RE: 3328 Verdun Avenue

I reviewed the drawings that you forwarded, read the materials supplied by the applicant, and visited the site. My comments and recommendations are summarized below.

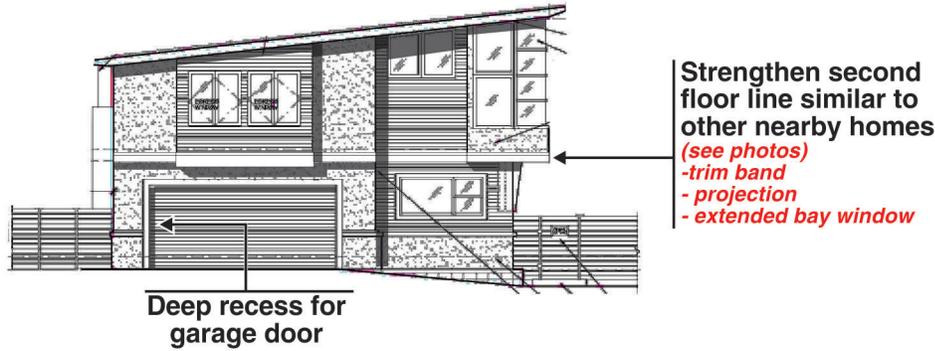
The proposal is to add a partial second floor to the existing house. Placement of the addition is proposed to be over the front of the house closest to Verdun Avenue. The home style would change from a gable fronted Ranch Style home to one that is more modern in appearance with a single sloped roof at the second floor addition. Bay windows at the new second floor bedrooms and Family Room are proposed to break up the two story walls facing the street. The proposed front elevation is shown below.

The proposed design seems well done, and appropriate to the scale of other nearby homes. The home design, while a bit more modern in appearance than some in the immediate neighborhood, is attractive and of a style that should be complementary to the street.

- The front facade has a substantial amount of two story wall surfaces relative to those in the immediate neighborhood.
- The second floor addition will block some views from the second floor main living spaces of the house immediately adjacent uphill of the site.

Flat roof on the adjacent house to the west

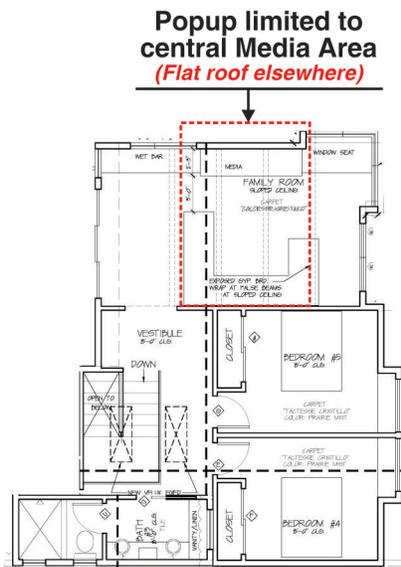
An effort has been made by the applicant to reduce the view impacts of the addition on the immediately adjacent neighbor to the west. Further mitigation could be achieved by the utilization of a flat second floor roof with the integration of a popup roof element over the central media area of the Family Room as shown on the floor plan and front elevation illustrations below. This flat roof form would be similar to the adjacent house to the west, and the popup could add to the uniqueness of the Family Room.

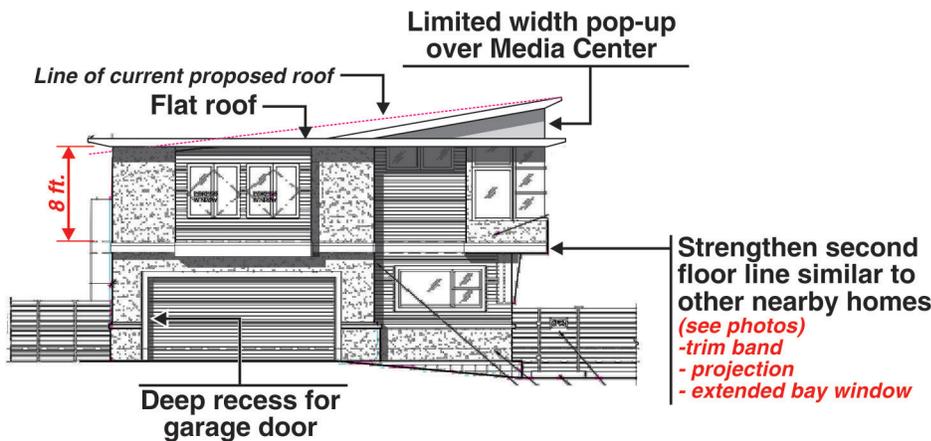
The applicant has made a start at relating to that condition by the projecting bay windows on the front facade which pick up the second floor projection approach of the nearby homes. This could be strengthened by the addition of belt trim at the second floor line, a projection of the bedrooms over the first floor facade, and the enhancement of the bay window at the bedrooms as shown on the illustration below. In addition, substantially recessing the garage door would add to the visual depth of the facade.
